# SAFETY ALERT SA0008

**SUBJECT:** Additional Electrical Protection

**MODELS AFFECTED:** CC11-100 and CC11-160 S/N 0001, 00002 through 00177.

**Figure 2 - View from under looking up behind instrument panel**

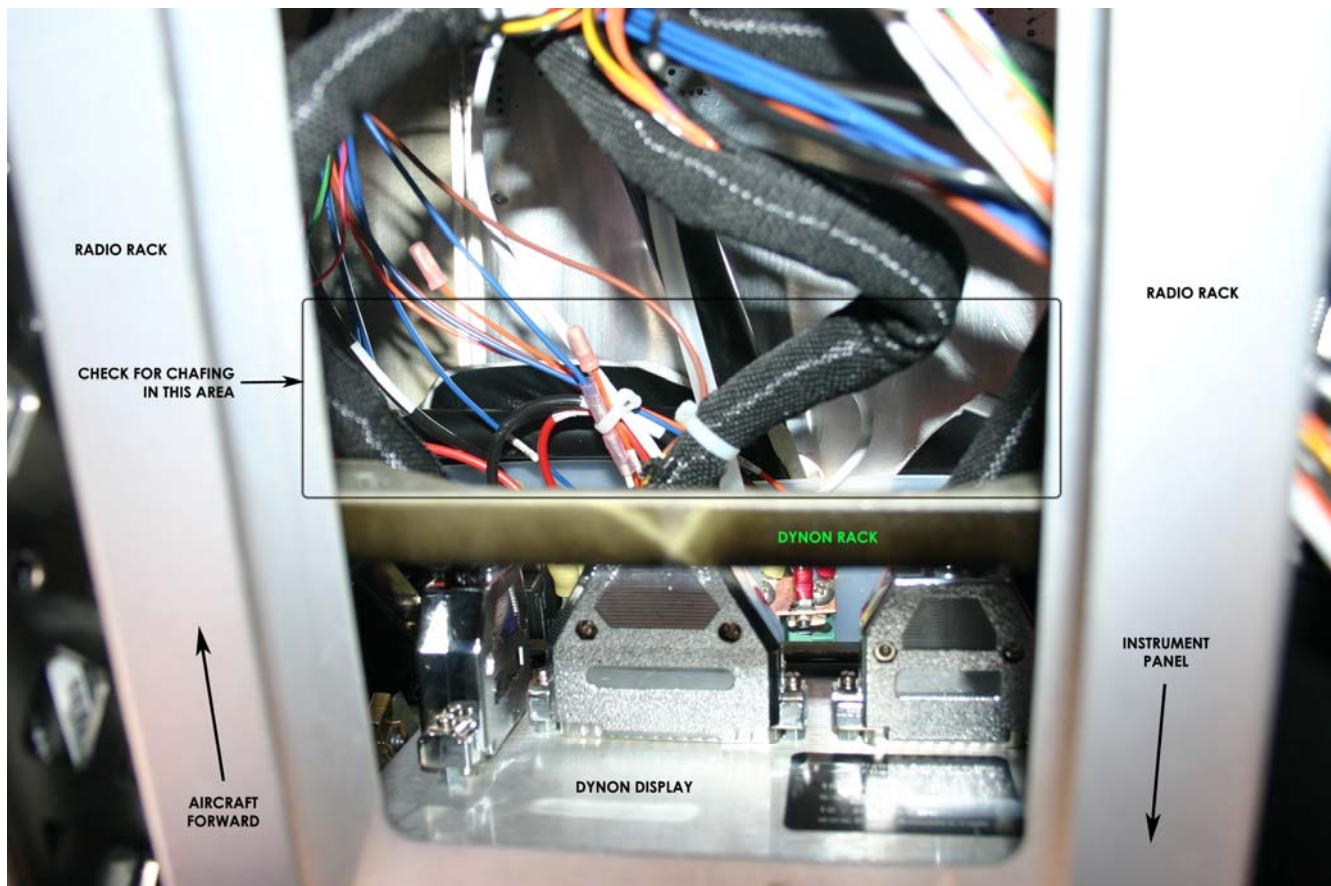
- v. Carefully inspect all wires, especially the ones that run from the circuit breakers and switches above the Dynon. Check for chaffing from contact with avionics or aircraft structure. (See Figure 2)

- b. Repair (if required).
  - i. If any wires are chaffed, repair per AC43.13 or AC65-15A. New jumpers may be fabricated using Mil-Spec 22759/16 (Tefzel) or equivalent wire. 12GA jumpers may be replaced with 10GA; 14GA or smaller may be repaired with a butt splice.
  - ii. If any wires are sagging and could possibly come into contact with the avionics, secure them in place.
- c. Installation of chafe protection.
  - i. Clean the upper part of the Dynon

**Figure 3 - Upper part of Dynon with chafe tape installed**

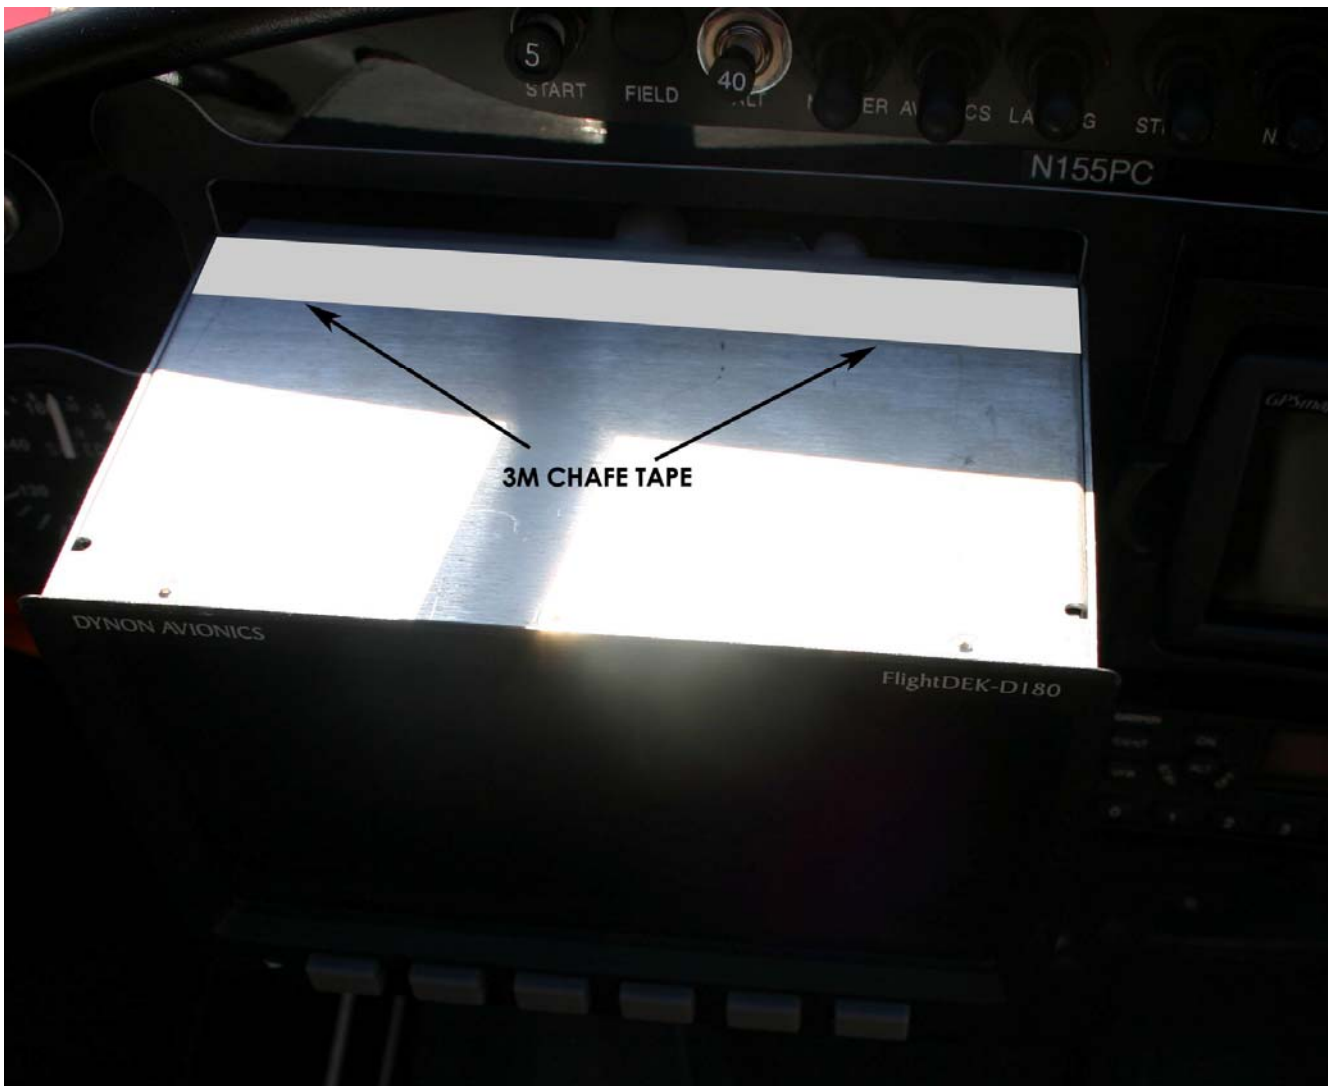
- ii. Apply 3M chafe tape along (aircraft) forward edge where wires might rub. (See Figure 3)

Figure 5 - View looking up through access

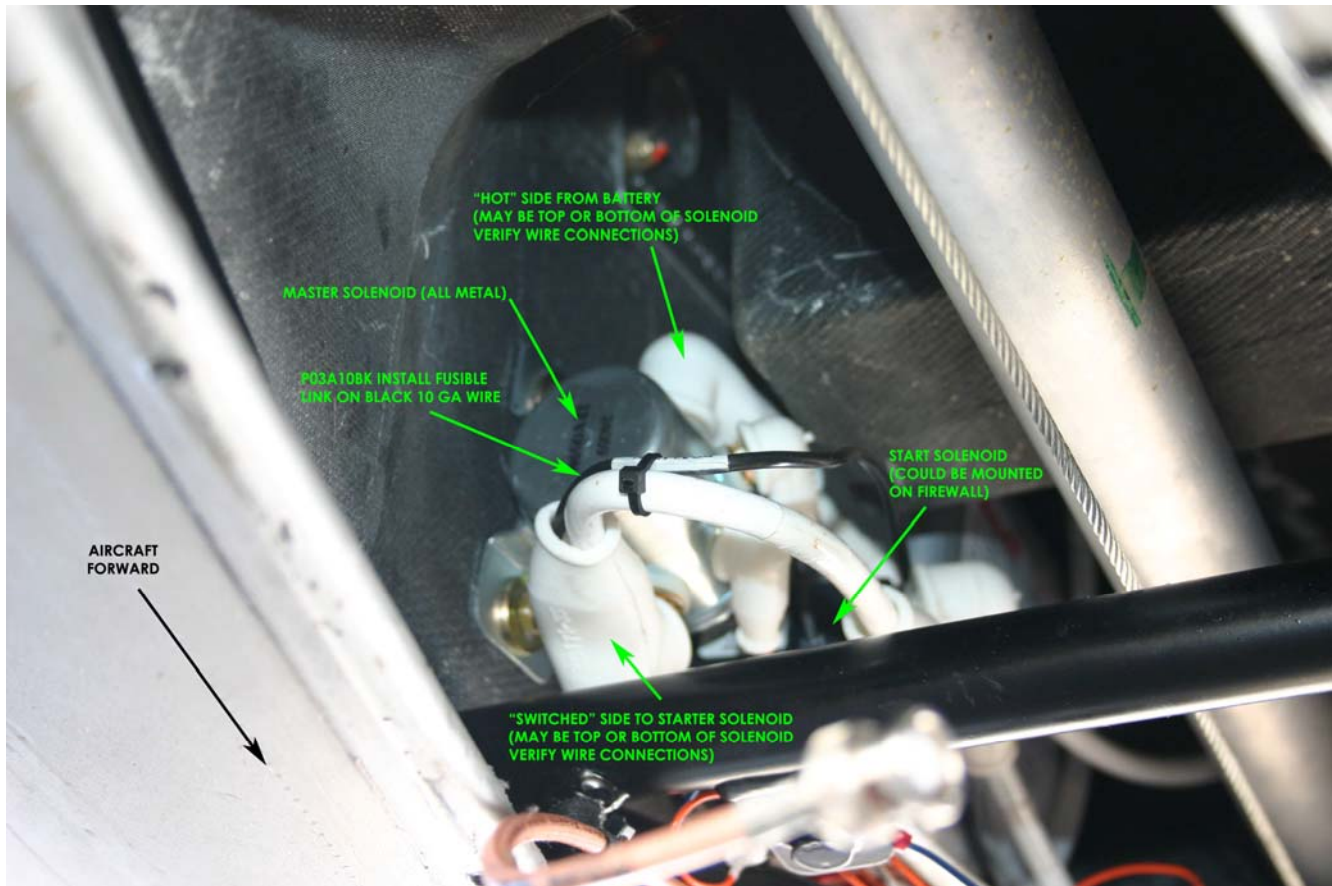
- b. Identify the black 10 GA wire attached to the Master Solenoid labeled: P03A10BK. (See Figure 5)

- i. Remove the ring terminal from the solenoid. Pull out the P03A10BK wire for proper fit and routing of a fusible link.
- ii. Clip off the existing ring terminal on P03A10BK

- iii. Crimp on the SC71021-001, Fusible Link, onto the P03A10BK wire per AC43.13 or AC65-15A. (See Figure 6)
